Addendum #1 - Bid Package #6929-06

Project Name: Lincoln Public Schools District Office
5901 'O' Street
Lincoln, NE
Project No.: 11065
Issued: June 15, 2012

Sketch A5
 Bid Package 6929-06
 Addendum 01

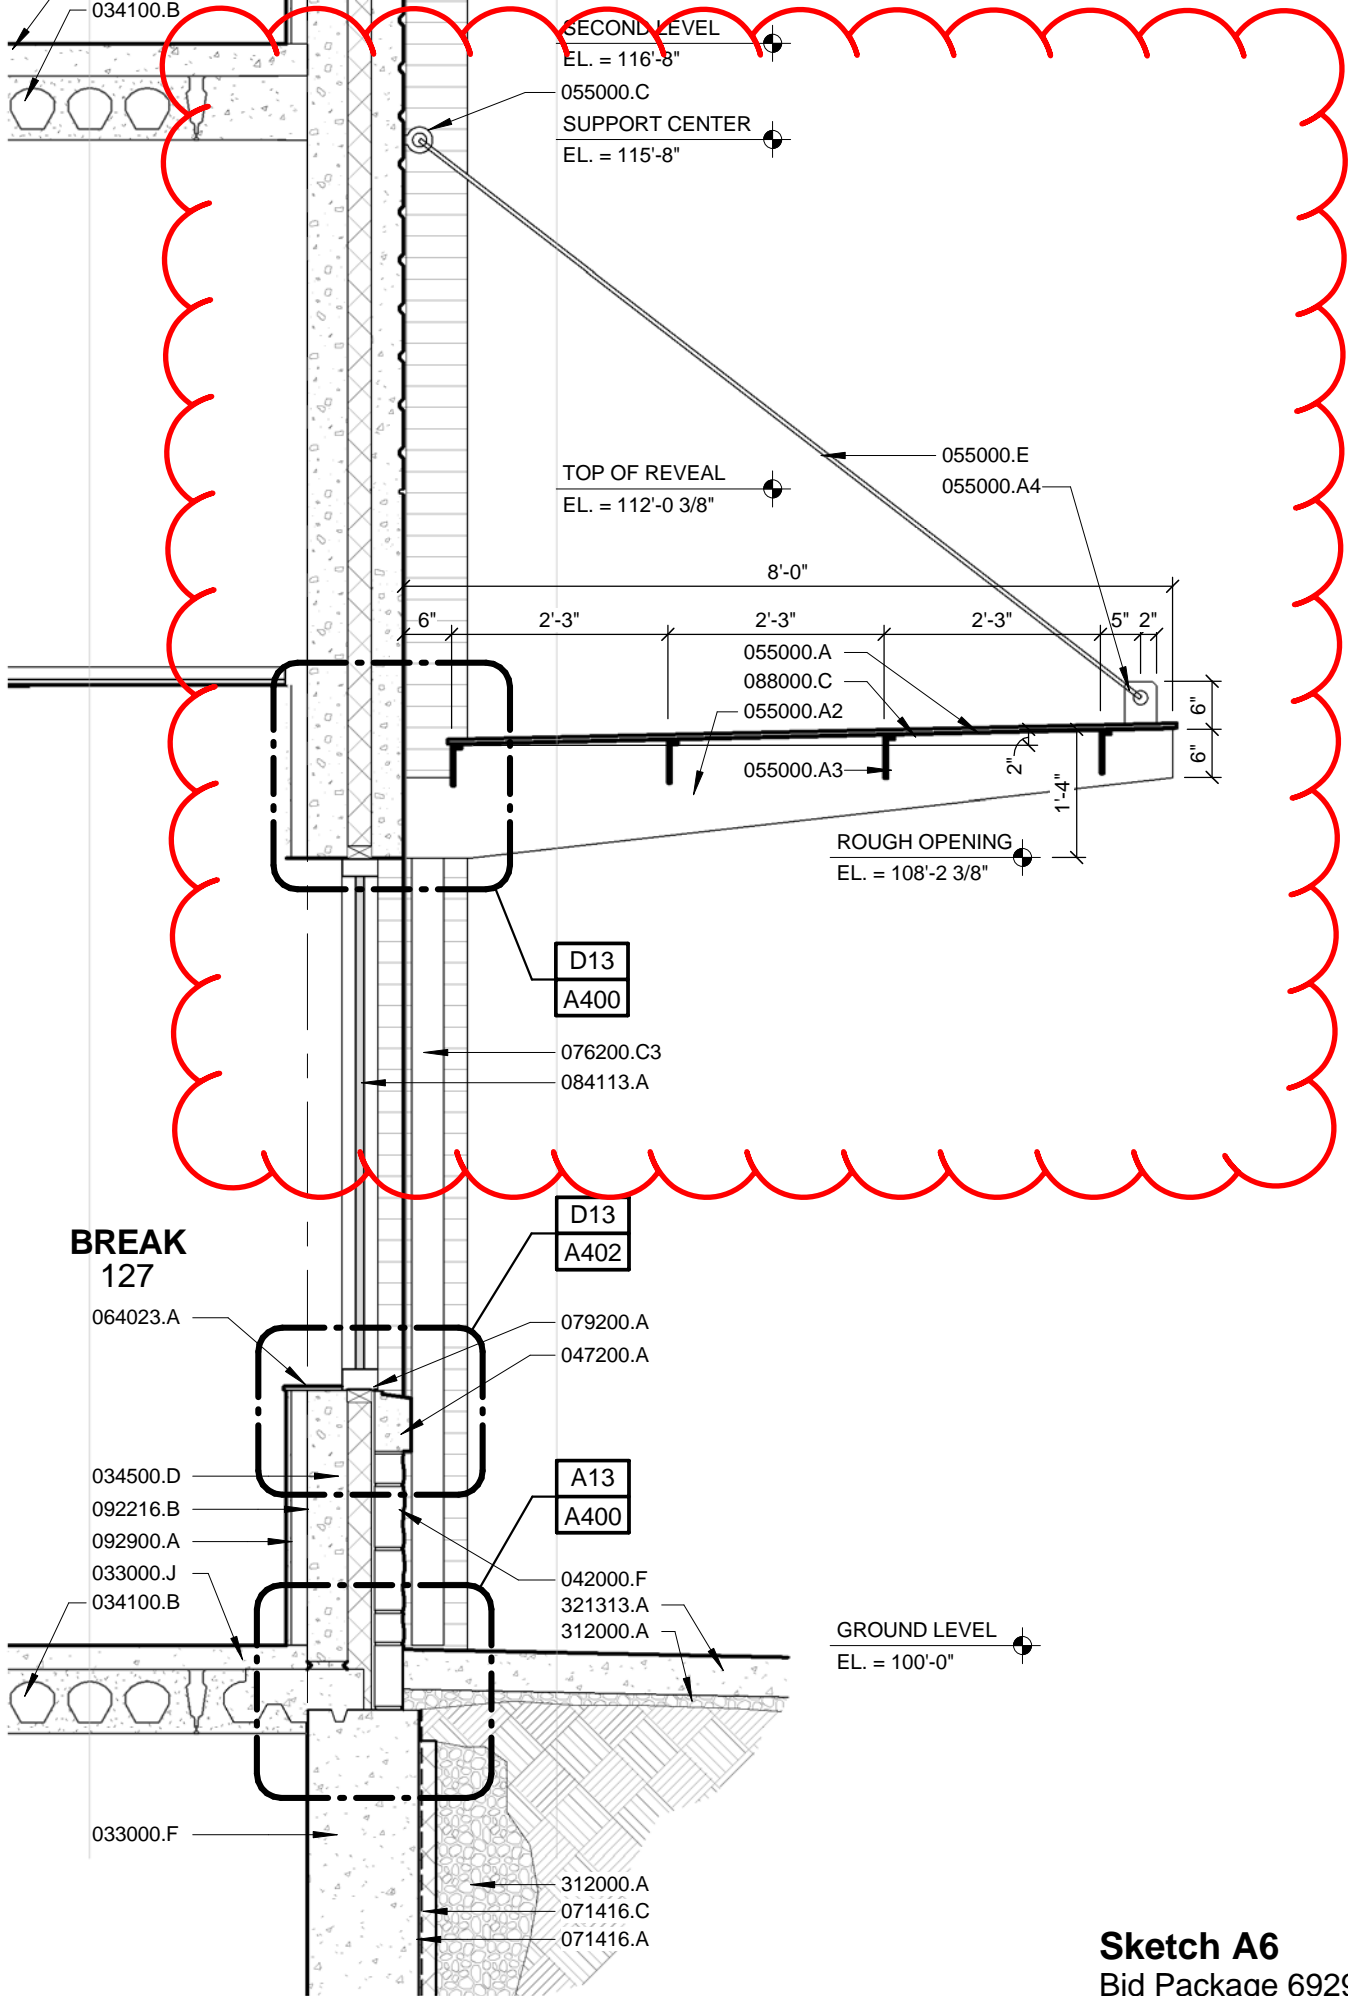
- ADD 1-22.** Refer to Sheet A200, Detail A1; Eliminate references to section and detail callouts G10/A400 and A9/A300.
- ADD 1-23.** Refer to Sheet A201, Detail H1; Between Grids 6 and 7 and Grids 8 and 9 above the Ground Level windows, note the modifications to the elevation due to the change in canopy height. Frames AL44 and AL45 have been added along with additional keynote information. Refer to attached **Sketch A5**.

Sketch A6
 Bid Package 6929-06
 Addendum 01

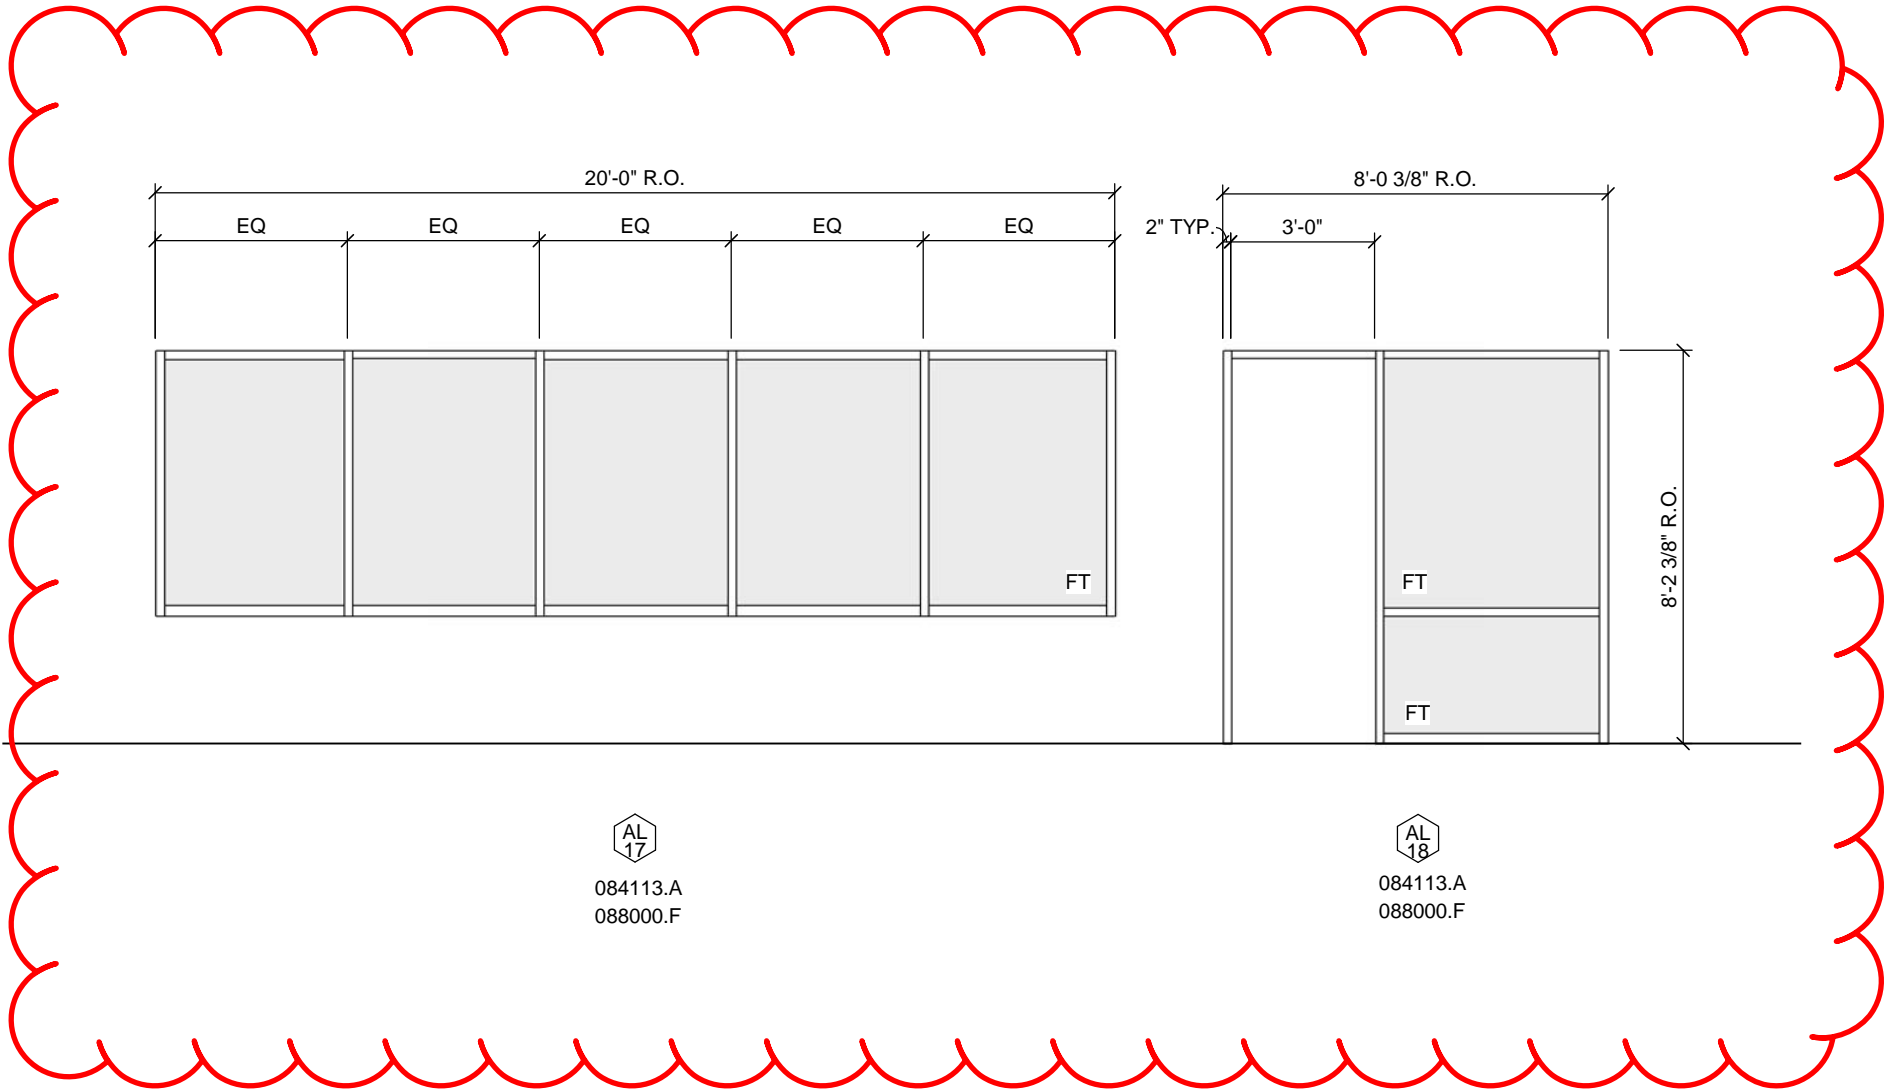
- ADD 1-24.** Refer to Sheet A301, Detail A1; The position and design of the canopy has been revised. Refer to attached **Sketch A6** for revisions to lower half of wall section.

Sketch A7
 Bid Package 6929-06
 Addendum 01

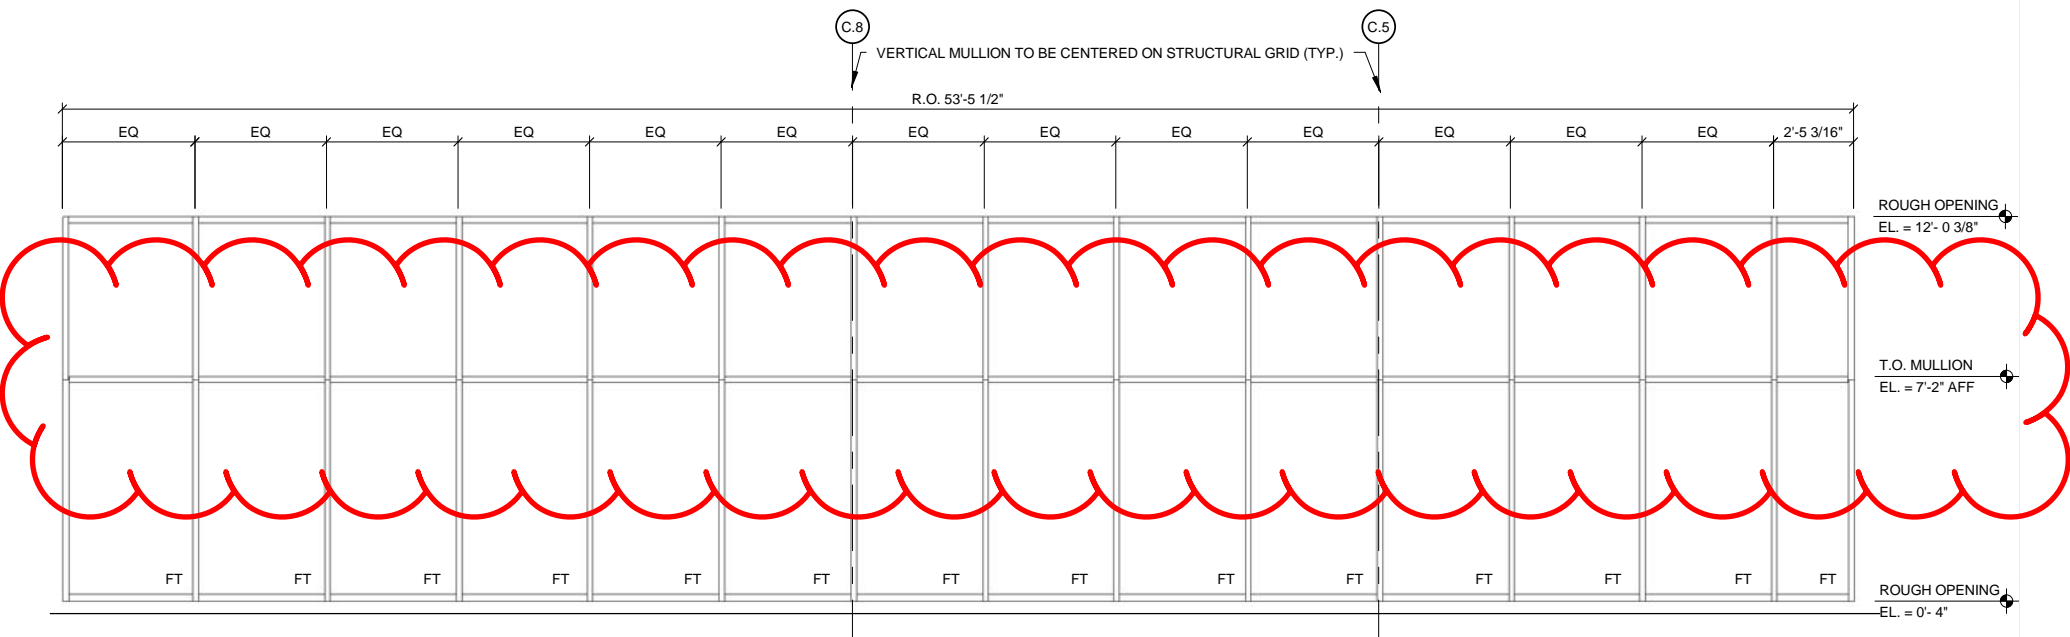
- ADD 1-27.** Refer to Sheet A500, Frame Type AL17 and AL18; Frames have been revised. Refer to attached **Sketch A7**.
- ADD 1-28.** Refer to Sheet A500, Frame Types AL22 and AL23; Add a horizontal mullion at 7'-2" AFF. Refer to attached sketches **Sketch A8** and **Sketch A9** respectively.

Sketch A10
Bid Package 6929-06
Addendum 01

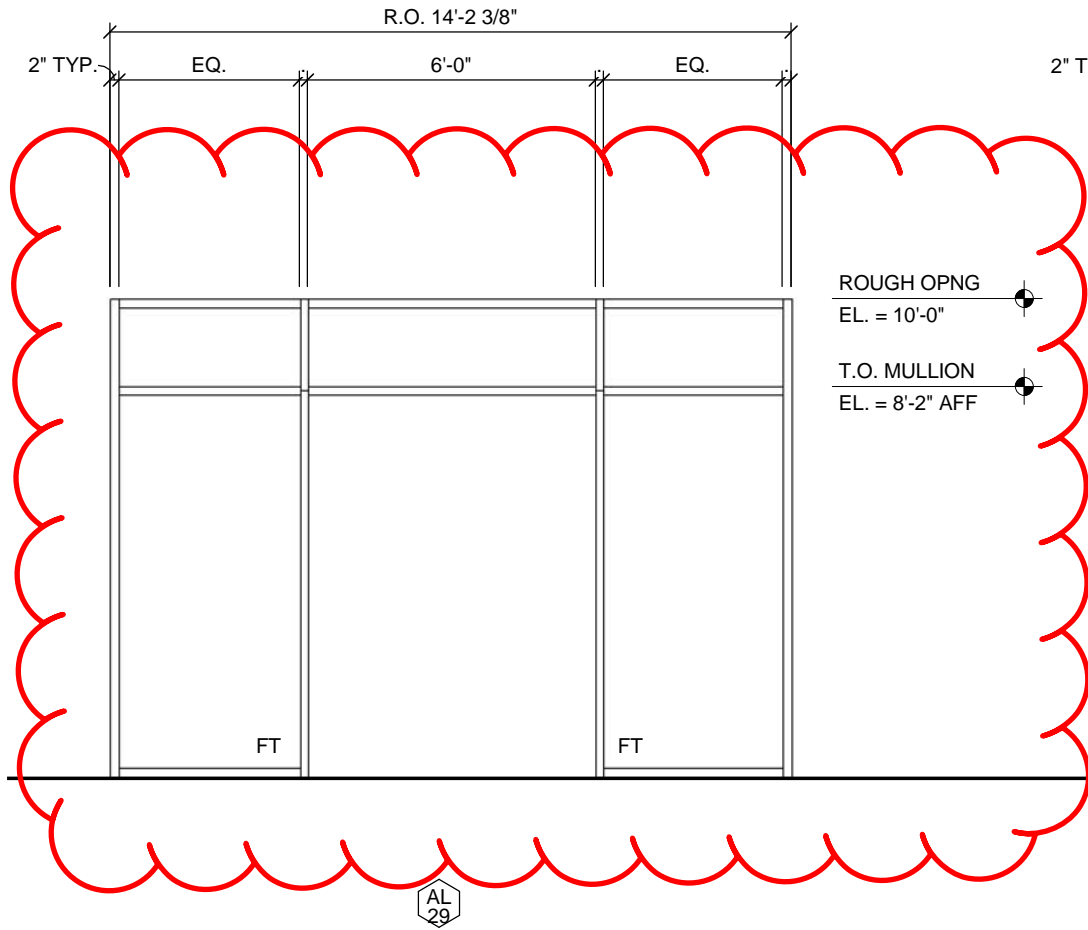
- All other horizontals are 2" in height.
- ADD 1-32.** Refer to Sheet A501, Frame Type AL28; Eliminate verticals from the sidelights as shown on the attached **Sketch A10**.

Sketch A11
Bid Package 6929-06
Addendum 01

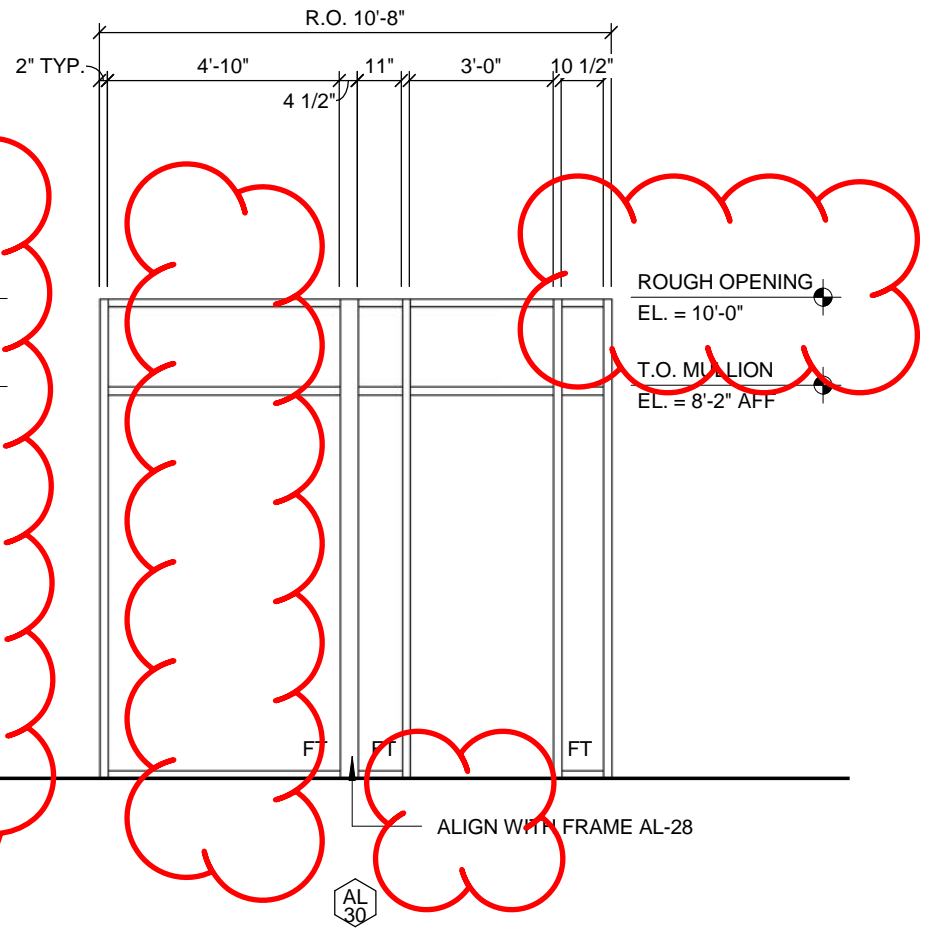
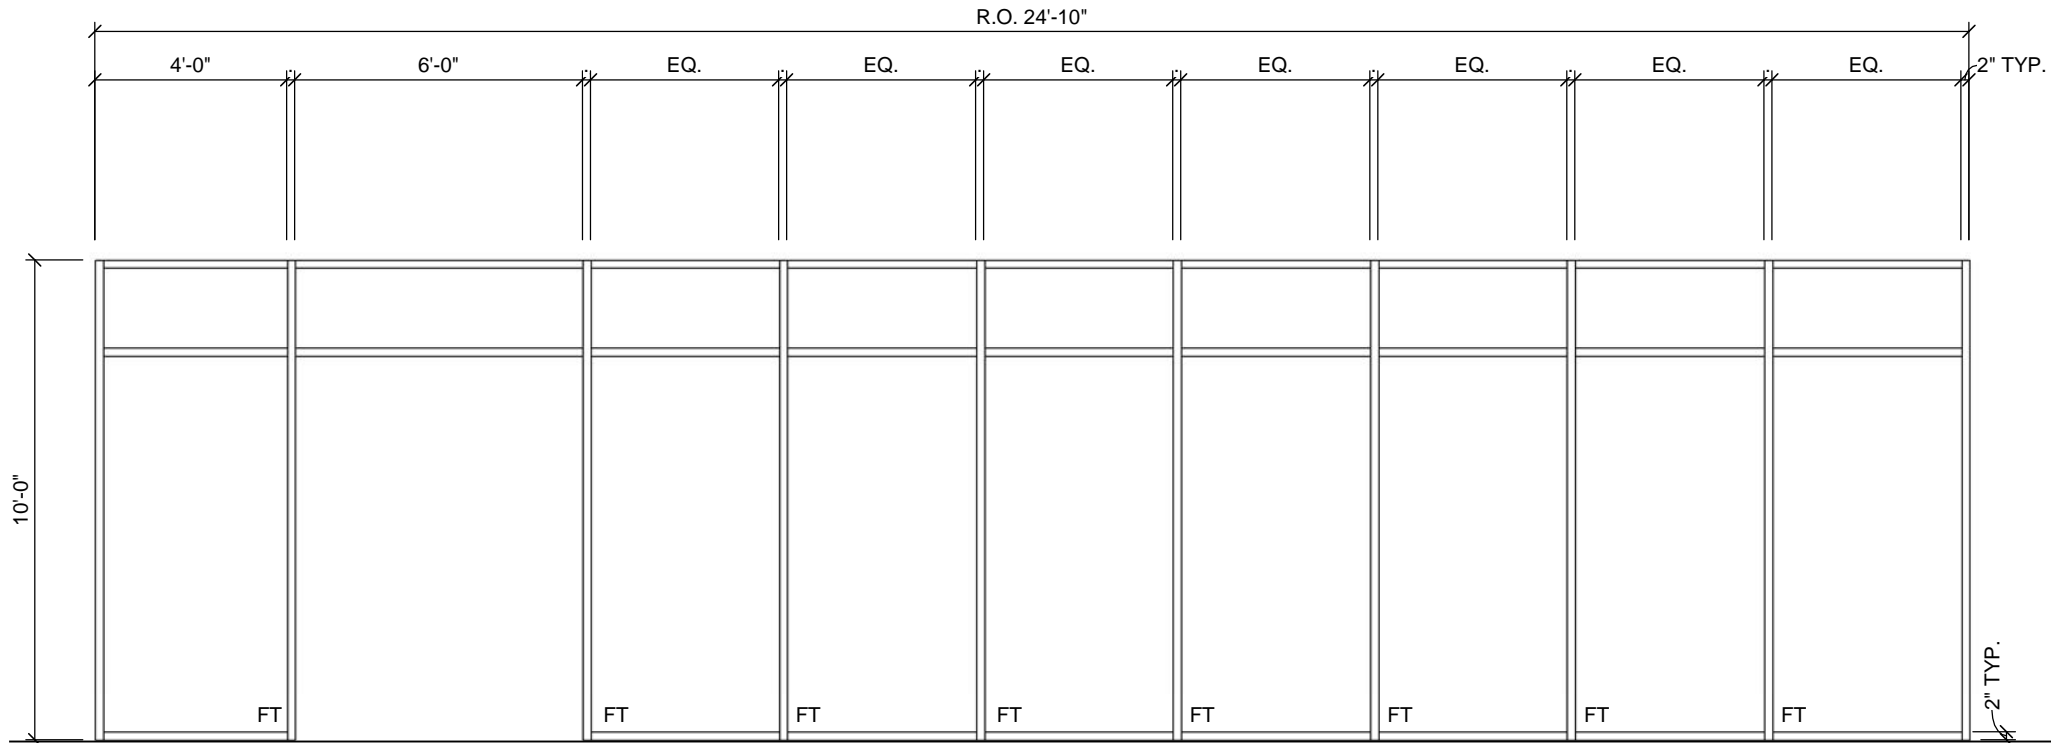
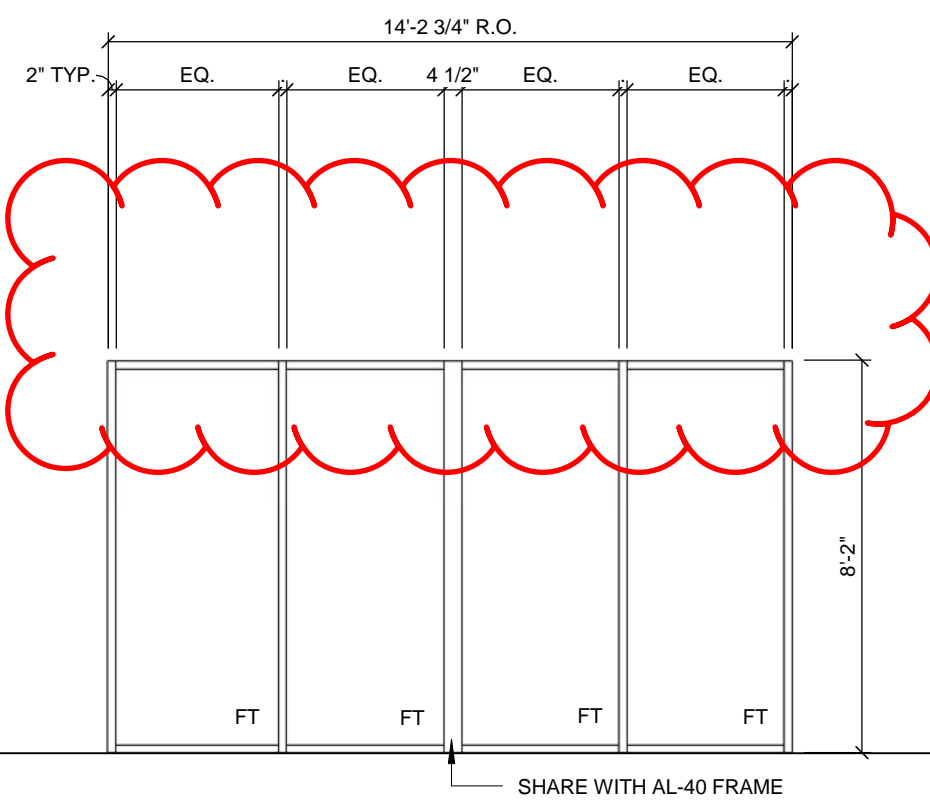
- ADD 1-33.** Refer to Sheet A501, Frame Type AL29; Modify the height of the frame and eliminate vertical mullions as shown on attached **Sketch A11**.

- ADD 1-34.** Refer to Sheet A501, Frame Type AL 30; Modify the height of the frame and eliminate a vertical mullion as shown on attached **Sketch A11**. Also note the modified text at the bottom of the frame.

Sketch A12
Bid Package 6929-06
Addendum 01

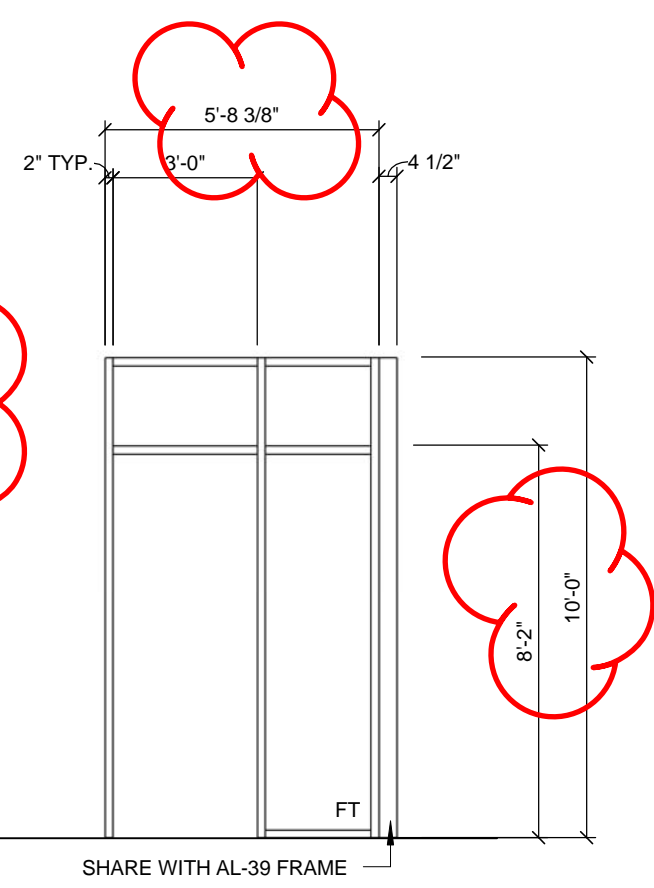
- ADD 1-35.** Refer to Sheet A501, Frame Type AL 34; Eliminate the transom panel. The rough opening for the top of frame is 8'-0" AFF.
- ADD 1-36.** Add Frame Type AL38 to Sheet A501. Refer to the attached **Sketch A12**.
